DEEPSEA YANTAI

DROPS INSPECTION PICTURE LOG

August 2023 | AXESS PROJECT NO 258034-16 | PO: TBA

Subject: Deepsea Yantai DROPS Inspection Picture log 2023			
Client: Odfjell Drilling		Installation: DeepSea Yantai	
Client contact onshore: Kenneth Andersen		Client contact offshore: Chief Engineer	Axess project manager: Elin Gjerde
Axess project no.: 258034-16		Client PO no.: TBA	Document no.: 258034-16-278-01
Revision: 02	Changes: Final report	Written by: Kjetil Ask	Approved by: Elin Gjerde
		28.09.2023	10.10.2023
Revision: 01	Changes: Preliminary report (MOB 2)	Written by: Kjetil Ask	Approved by:
		28.09.2023	
Revision: 00	Changes: Preliminary report (MOB1)	Written by: Roger Eidem	Approved by:
		21.08.2023

Finding: 4.2

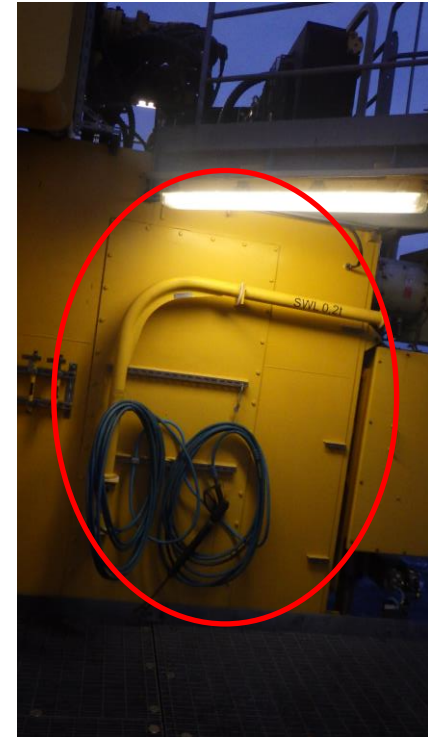
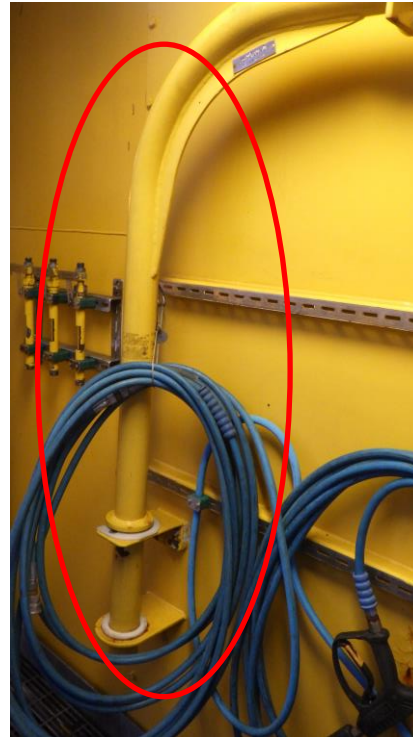
Description: Loose swing beam has no secondary retention

Required action: Install secondary retention

Finding: 4.3

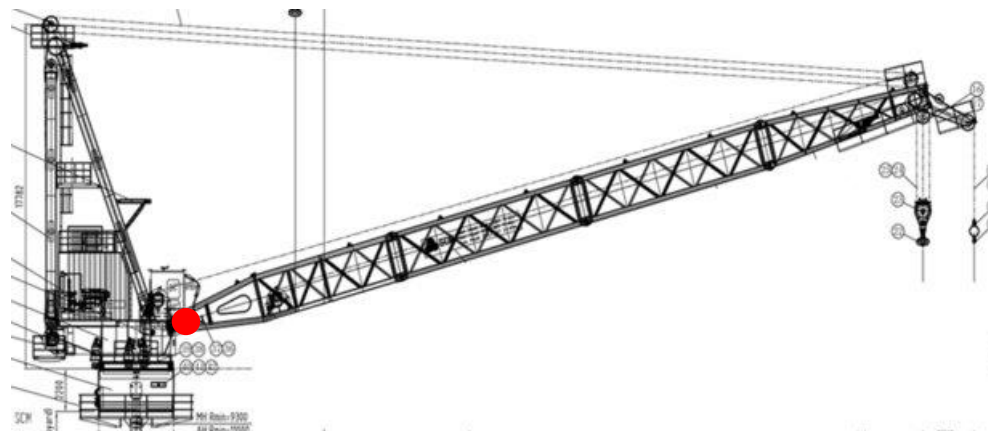
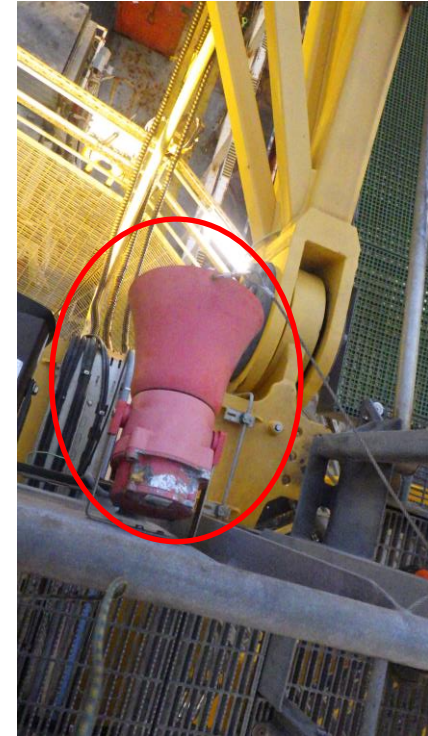
Description: The plastic for the foghorn is broken which makes the secondary retention not active

Required action: Install new foghorn

Finding: 5.2

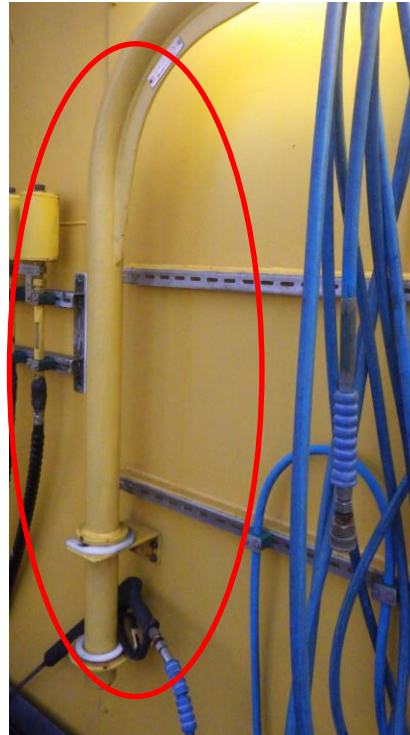
Description: Loose swing beam has no secondary retention

Required action: Install secondary retention

Finding: 5.3

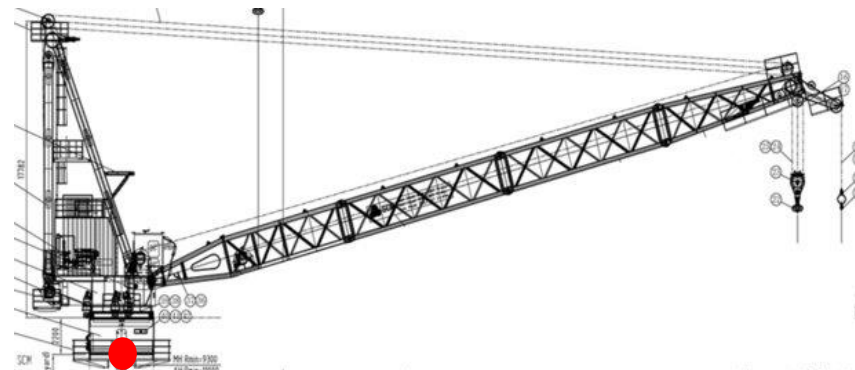
Description: Equipment at height
without secondary retention

Required action: Install secondary
retention

Finding: 6.2

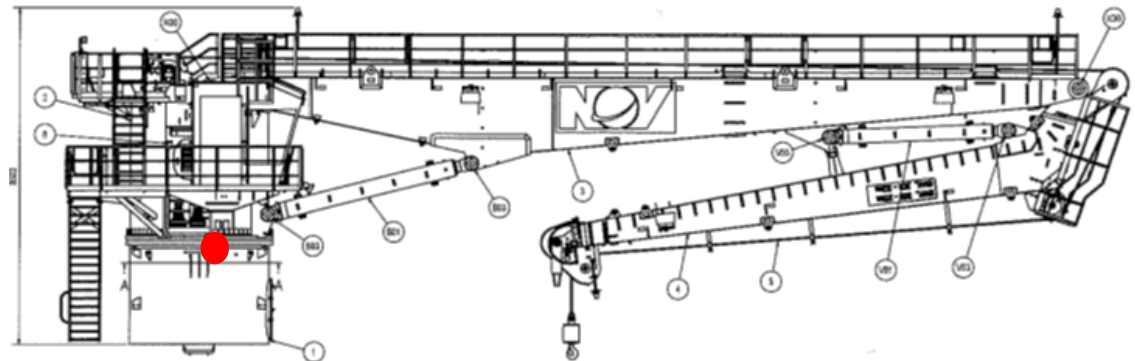
Description: Washer used for bolt is too small

Required action: Remove old washer and apply correct size washer
